KAWARTHA PINE RIDGE DISTRICT SCHOOL BOARD
PUR24-100-ITT
Murray Centennial Public School Addition

ADDENDUM NO. 3

Add (1): Architectural Addendum No. 2, Prepared by Moffet and Duncan Architects Inc. (34 Pages)

9 PHASE 3 - DEMO RCP
A2.0 1:150

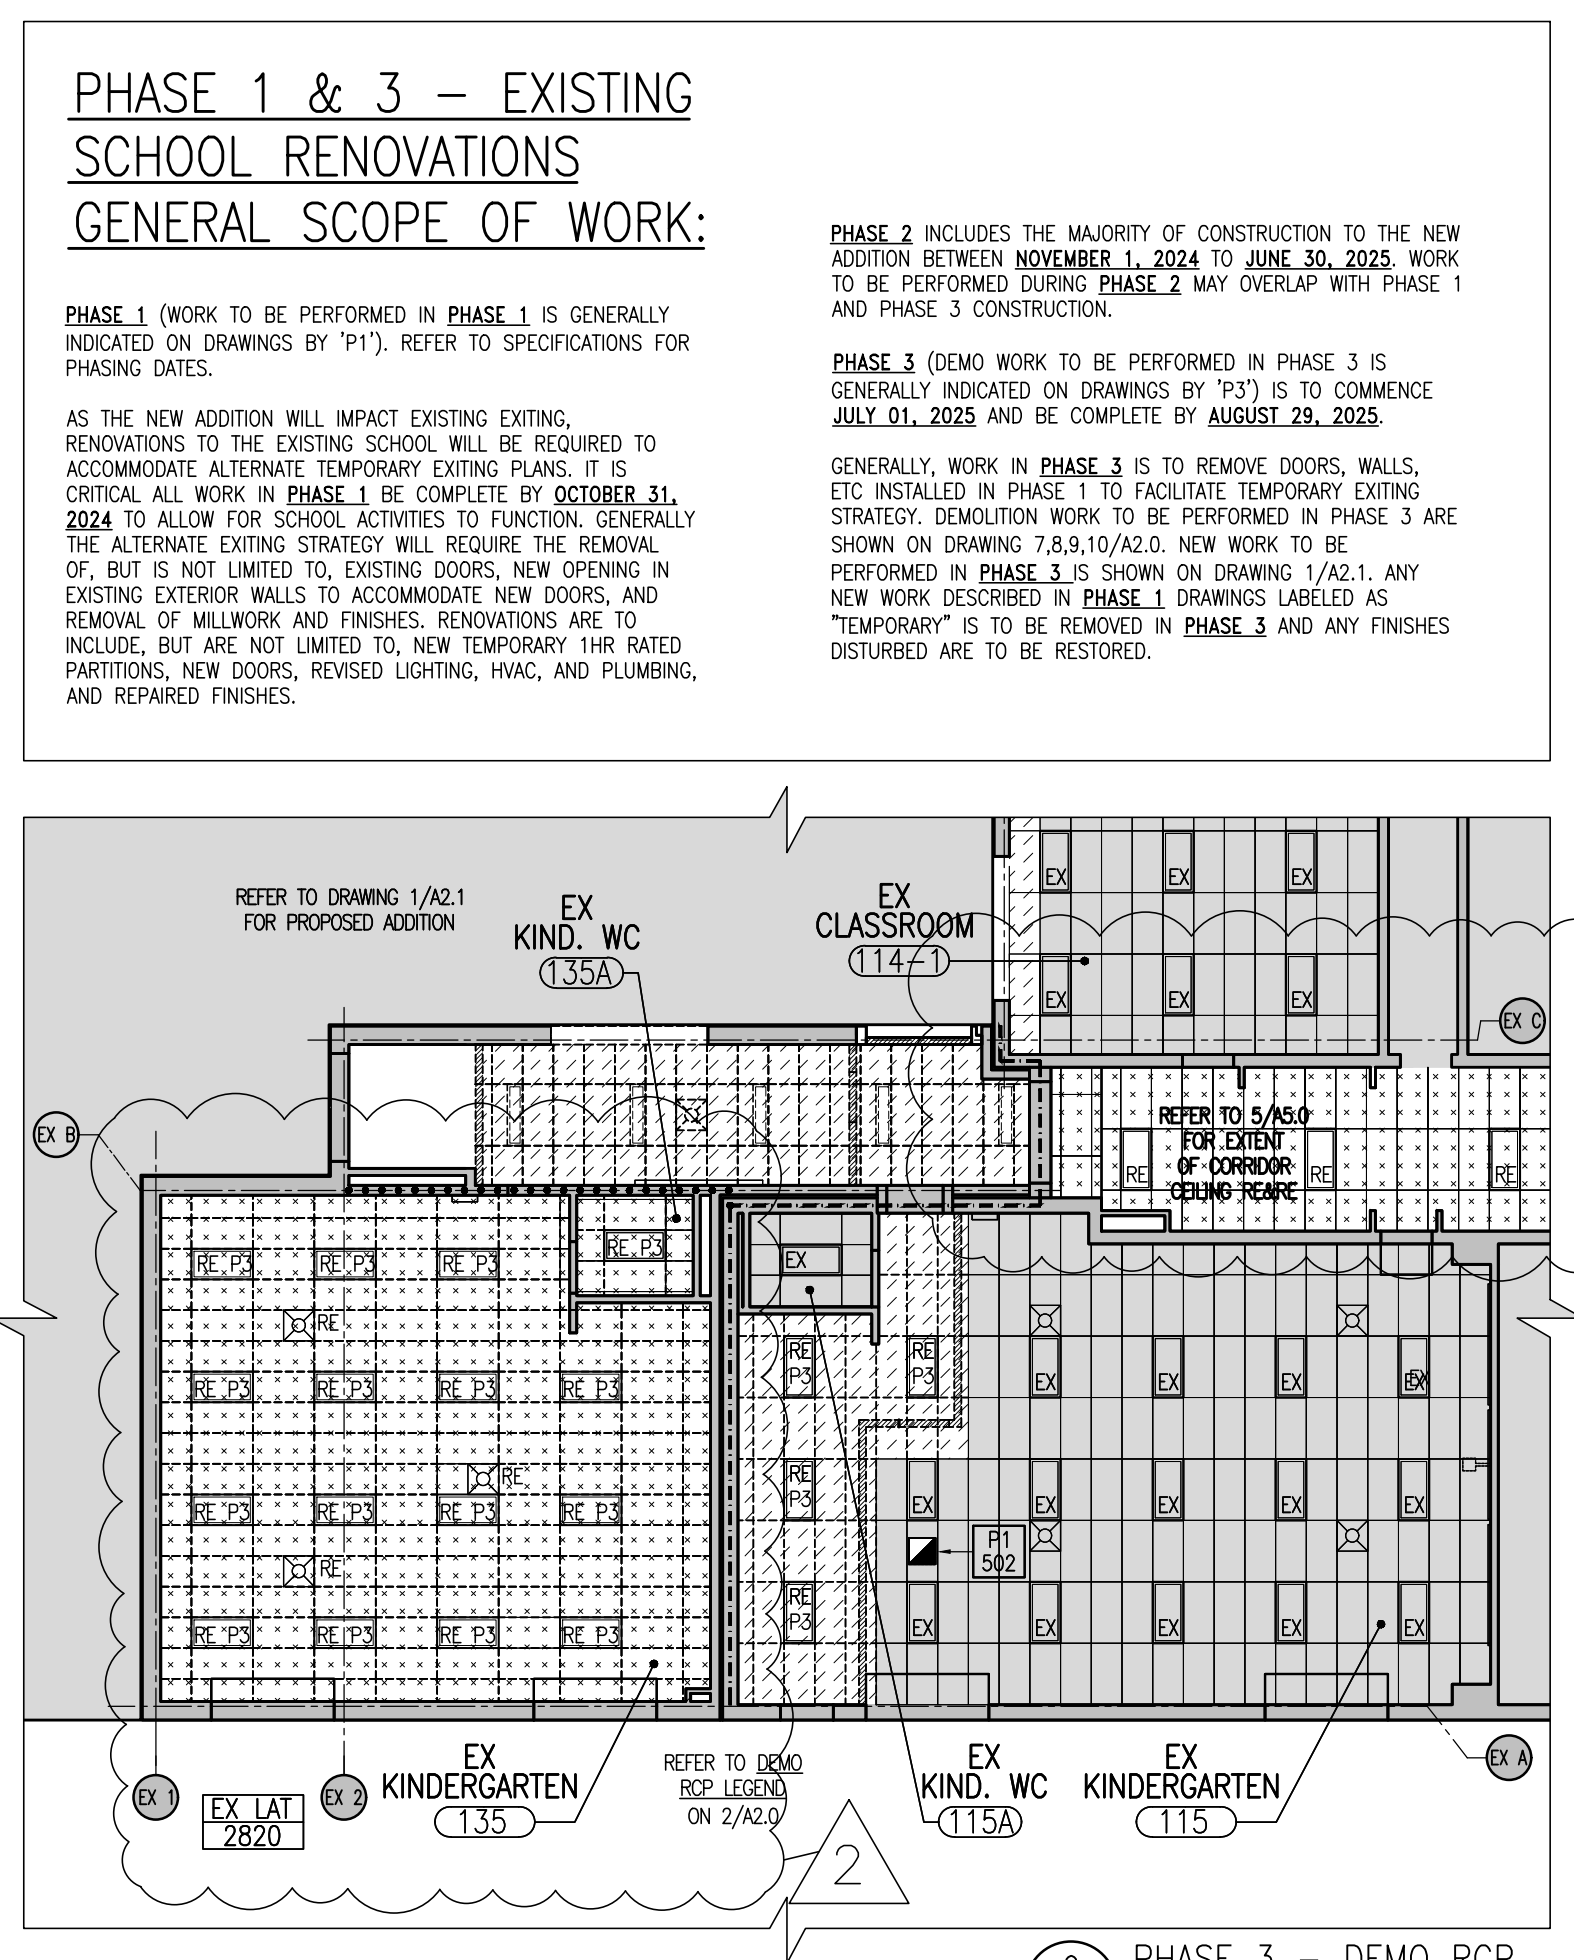
- .1 Replace Drawing A2.0 with enclosed Drawing A2.0 Addendum 2.
- .2 Refer to "DEMO RCP LEGEND" on Dwg 2/A2.0 for additional note "DENOTES AREA OF EX FIRE RATED ACOUSTIC CEILING TILE & TBAR GRID TO BE REMOVED & REINSTATED"
- .3 Refer to Dwg 9 & 10/A2.0 for additional area of ex ATC and lighting removal and reinstallation.

DWG. NO.
ADD-1

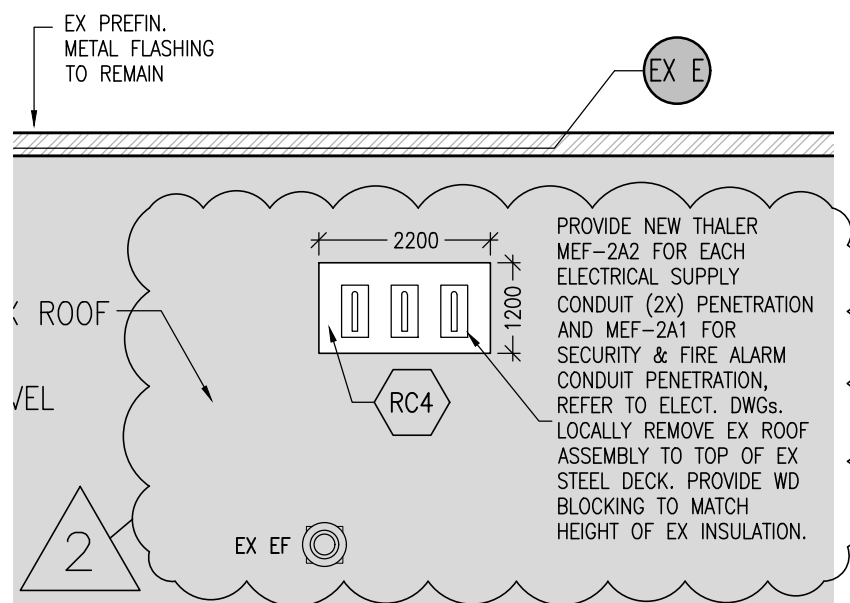
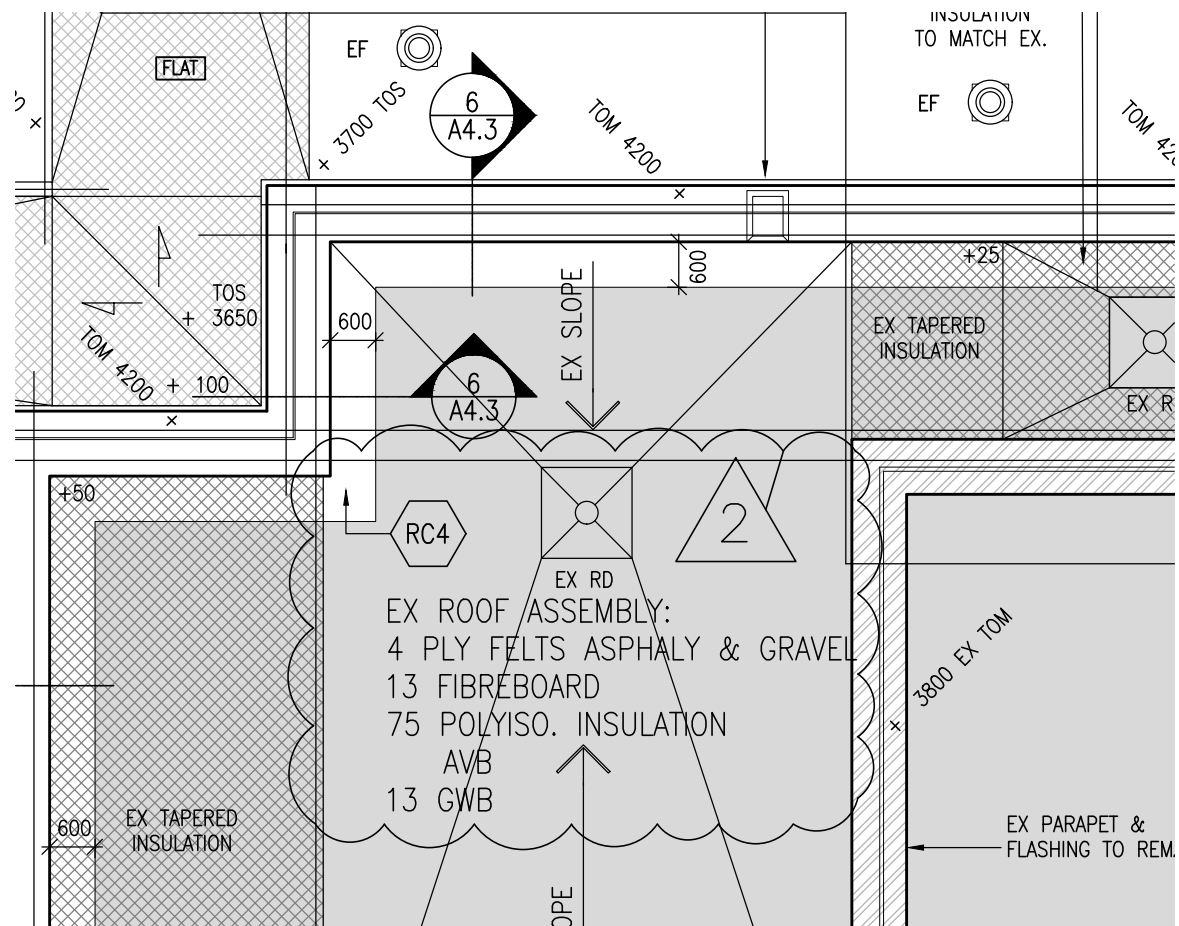
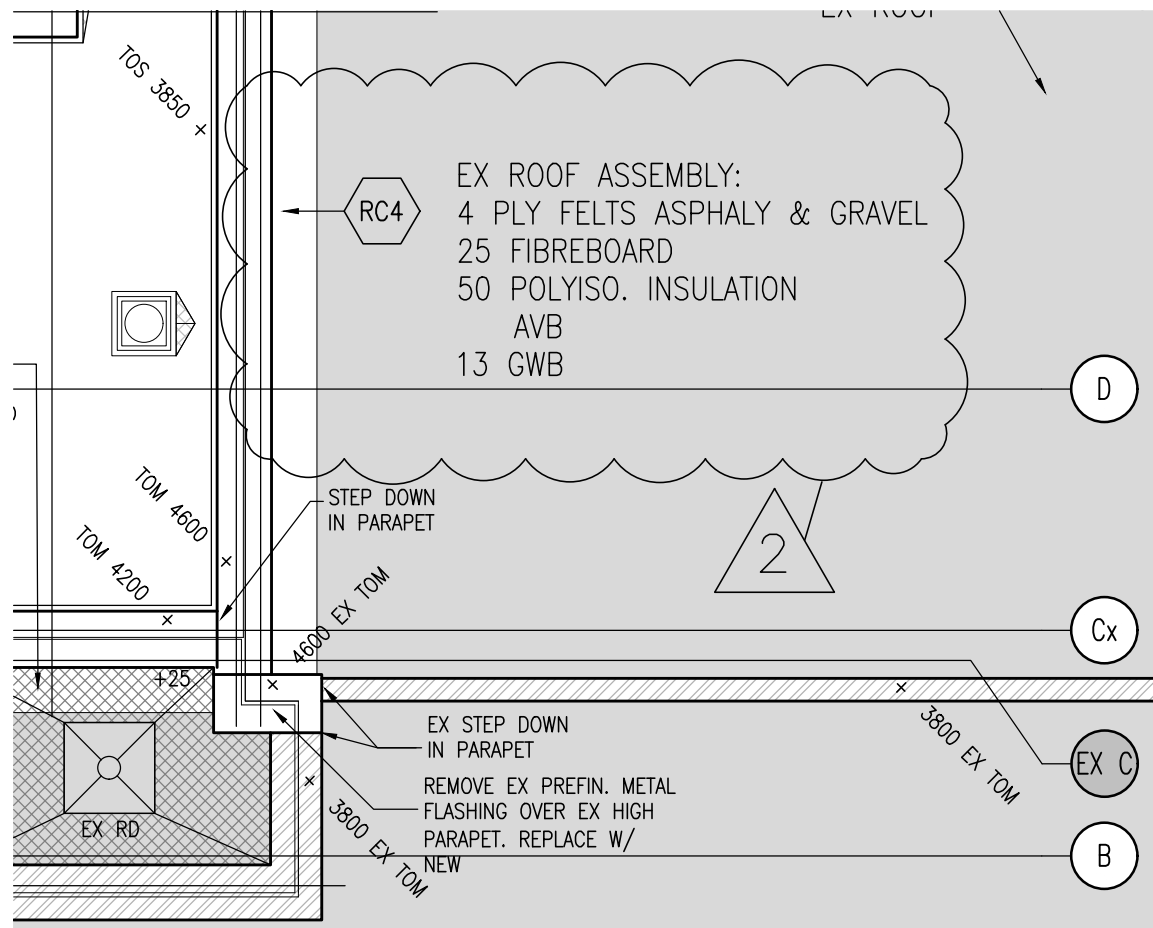
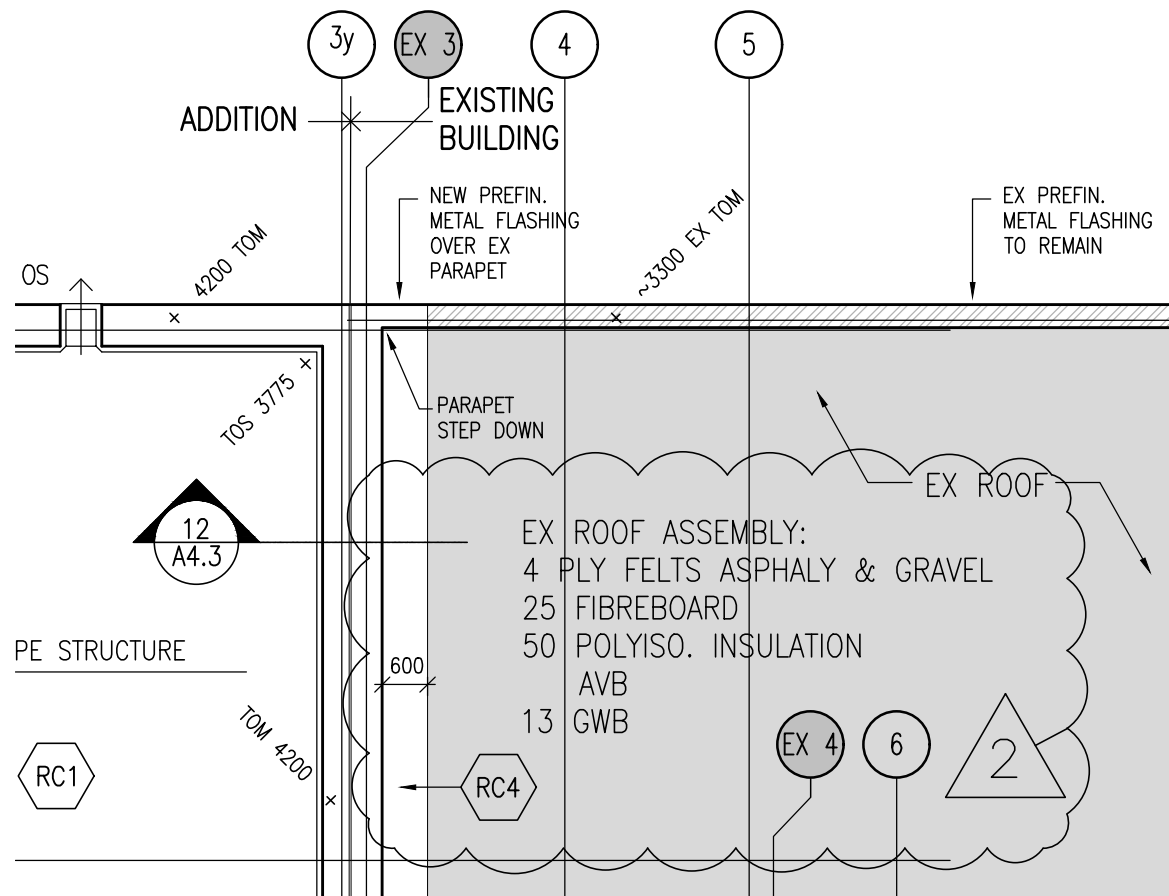
- .1 Refer to ADD-1 Plan detail 5/A2.2 and 7/A2.2 for revised Plan details to include new steel channel and flashing.

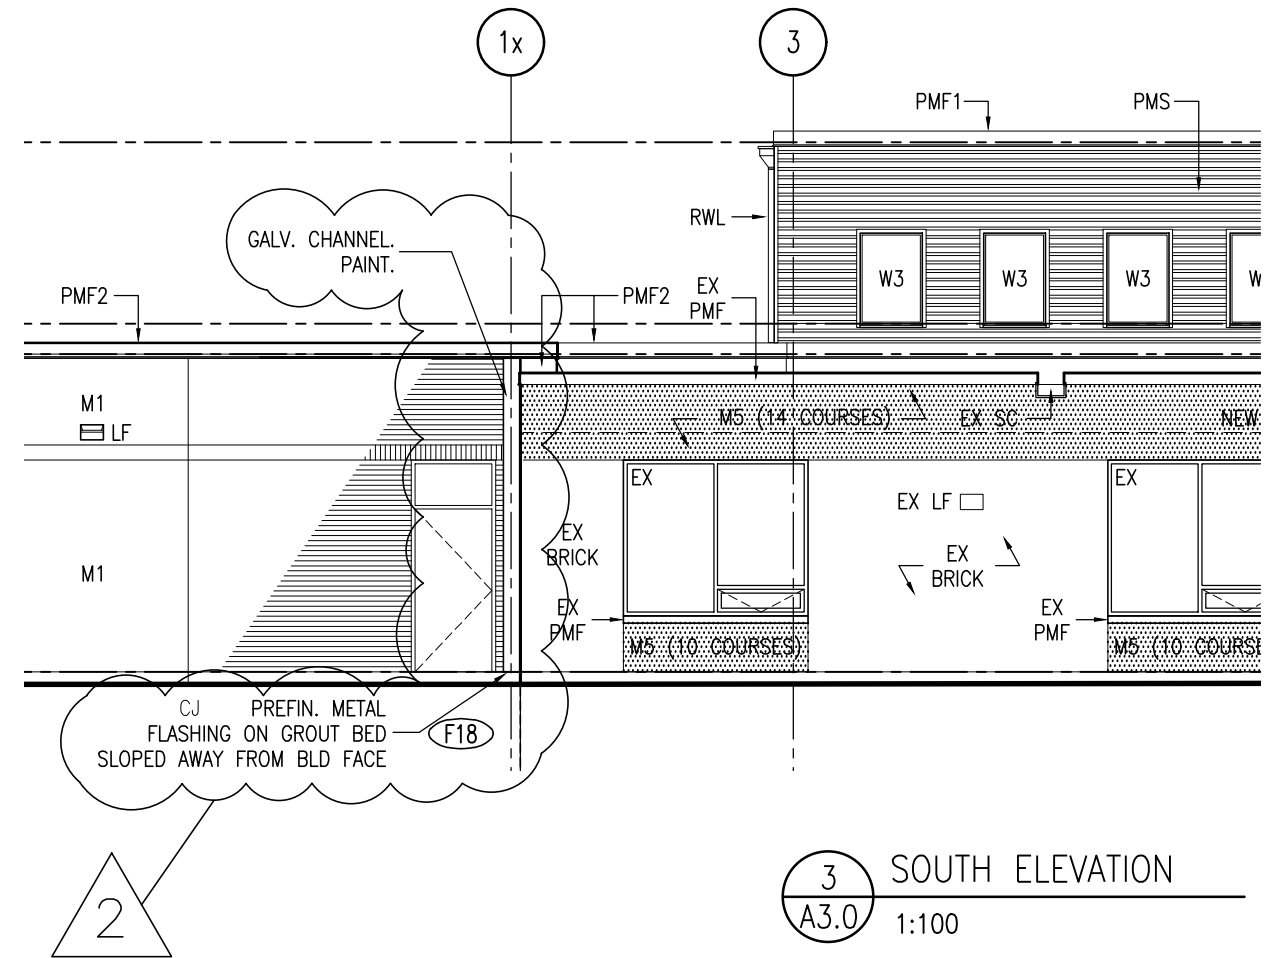
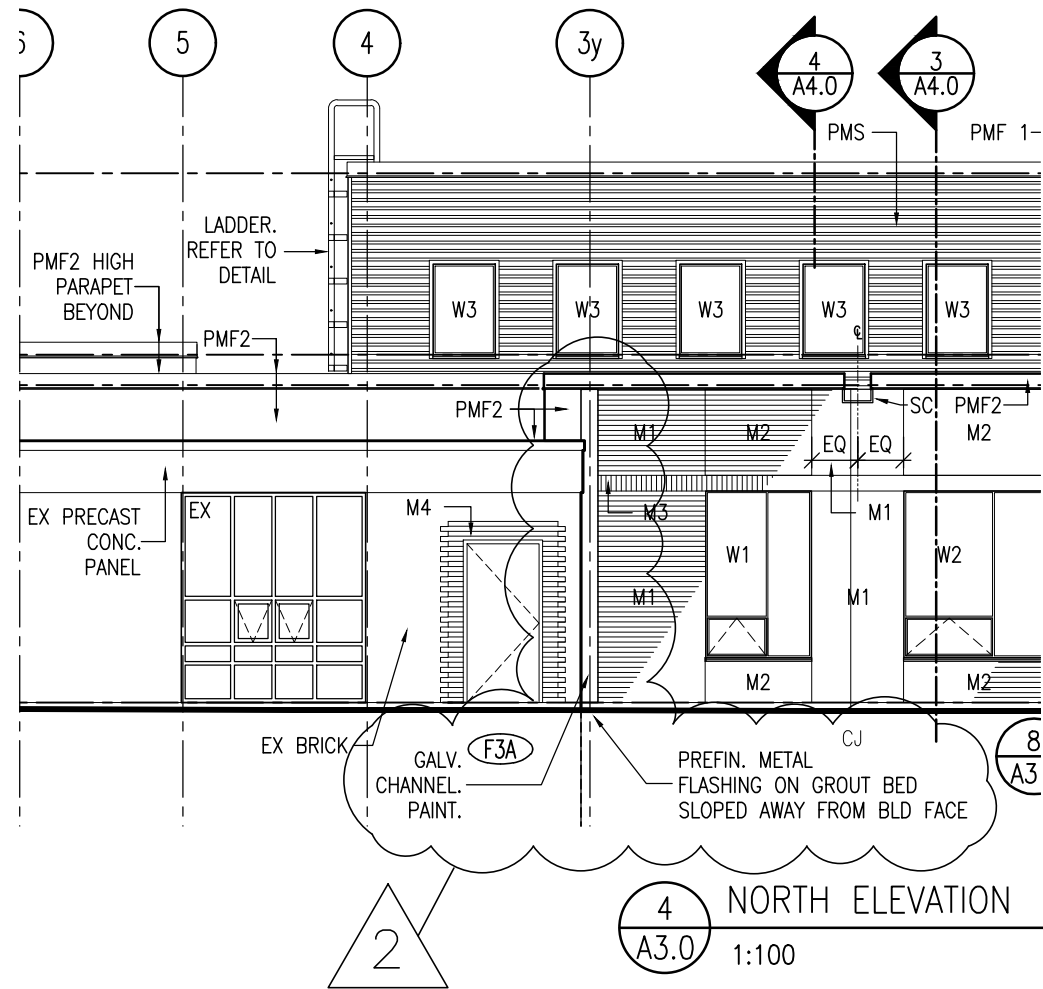
Question 2: As per Drawing A4.1, RC4 specifies to remove existing gravel, BUR, Insulation, AVB, & Gypsum Board down to existing steel deck. Could you please provide more specific details regarding the composition of the existing roof assembly (i.e., Insulation thickness, vapor barrier type, thicknesses of assembly material)?

- .1 Refer to ADD-2 for existing roof assembly noted on Dwgs and, new electrical roof penetrations.
- .2 Refer to ADD-3 for revised "Roof Construction Assemblies" legend.

Answer 2: Refer to Part 2 Additional Information, Add (1): Architectural Addendum No 2 for revised drawing 1/A2.3 for additional information on existing roof assembly.

REMOVE EXISTING GRAVEL, BUR, INSULATION, AVB, &
 GYPSUM BOARD DOWN TO EXISTING STEEL DECK.
 PROVIDE NEW 13MM DENS-DECK SHEATHING,
 AVB, INSULATION, & SLOPED INSULATION TO
 MATCH EX THICKNESS. PROVIDE NEW SEBS BUR.
 OVERLAP EX ROOF MEMBRANE 600mm. TIE NEW
 AVB INTO EXISTING.
 REFER TO ROOF PLAN FOR EXISTING
 ROOF ASSEMBLY.
